Access Compliance Report

Public Rights-of-Way

(Pedestrian Signals)

Intersection ID: N/A	Main Street:	Cross Street: N/A	Location: N/A
ADA ID: A7DE555B6F5F	Signal Type: One Push Button-Non APS	Overall Compliance: No	Severity Score: BTN 1: N/A BTN 2: N/A No BTN: N/A
Codes/Mitigation Info/Possible Solution		Field Measurements/Component Compliance

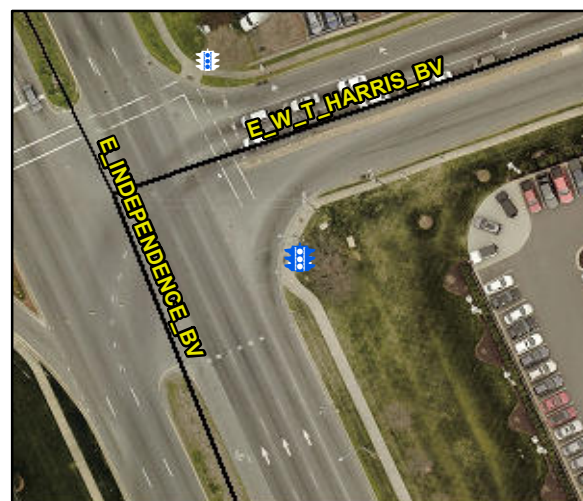
Compliance	Description	Data	Compliance	Description	Data
	Button Count	Button1	N/A	Distant to Additional Button (in)	N/A
	Additional Button Present?	No		Additional Button ID	N/A
N/A	Signal Buttons Required?	N/A	N/A	Additional Ped Posts Required	N/A
	How Many Ped Street Xings?	1		Located In An Island/Median?	No
N/A	B 1 Sign Present?	Yes	N/A	B 2 Sign Present?	N/A
Yes	B 1 Sign Purpose?	Yes	N/A	B 2 Sign Purpose?	N/A
Yes	B 1 Sign Lettering & Contrast?	Yes	N/A	B 2 Sign Lettering & Contrast?	N/A
Yes	B 1 Parallel To XWalk?	Yes	N/A	B 2 Parallel To XWalk?	N/A
Yes	B 1 PAR to Button?	No	N/A	B 2 PAR to Button?	N/A
No	B 1 PAR to XWalk?	Yes	N/A	B 2 PAR to XWalk?	N/A
Yes	B 1 Clear Floor Space?	Yes	N/A	B 2 Clear Floor Space?	N/A
No	B 1 FWD Approach?	No	N/A	B 2 FWD Approach?	N/A
N/A	B 1 FWD Approach Constrained?	N/A	N/A	B 2 FWD Approach Constrained?	N/A
N/A	B 1 FWD Approach Reach (in)	N/A	N/A	B 2 FWD Approach Reach (in)	N/A

N/A	B 1 FWD Approach Width (in)	N/A	N/A	B 2 FWD Approach Width (in)	N/A
N/A	B 1 FWD Approach Obstruction?	N/A	N/A	B 2 FWD Approach Obstruction?	N/A
N/A	B 1 FWD Approach Obstruction Dist (in)	N/A	N/A	B 2 FWD Approach ObstructionDist (in)	N/A
No	B 1 PARA Approach?	No	N/A	B 2 PARA Approach?	N/A
N/A	B 1 PARA Approach Constrained?	N/A	N/A	B 2 PARA Approach Constrained?	N/A
N/A	B 1 PARA Approach Reach (in)	N/A	N/A	B 2 PARA Approach Reach (in)	N/A
N/A	B 1 PARA Approach Width (in)	N/A	N/A	B 2 PARA Approach Width (in)	N/A
N/A	B 1 PARA Approach Obstruction?	N/A	N/A	B 2 PARA Approach Obstruction?	N/A
N/A	B 1 PARA Approach Obstruction Dist (in)	N/A	N/A	B 2 PARA Approach ObstructionDist (in)	N/A
Yes	B 1 Clear Floor Space Slope (%)	3.3	N/A	B 2 Clear Floor Space Slope (%)	N/A
No	B 1 Clear Floor Space XSlope (%)	7.9	N/A	B 2 Clear Floor Space XSlope (%)	N/A
N/A	B 1 PAR Slope (%)	3.7	N/A	B 2 PAR Slope (%)	N/A
Yes	B 1 Height (in)	39.0	N/A	B 2 Height (in)	N/A

Yes	B 1 Clear Xing Direction?	ClearlyMarked	N/A	B 2 Clear Xing Direction?	N/A
	B 1 Crossing Direction	To NW		B 2 Crossing Direction	N/A
No	B 1 DistanceTo XWalk (in)	76.0	N/A	B 2 DistanceTo XWalk (in)	N/A
No	B 1 DistanceTo Curb (in)	112.0	N/A	B 2 DistanceTo Curb (in)	N/A
Yes	B 1 Diameter (in)	2.0	N/A	B 2 Diameter (in)	N/A

Possible Solutions: Replace Signal Push Button With APS Button on New Post. Remove & Relocate Sign.

PROW/ADA: TMUTCD 4e.08, R404.3, R404.2, R404.7.1, R404.7.2
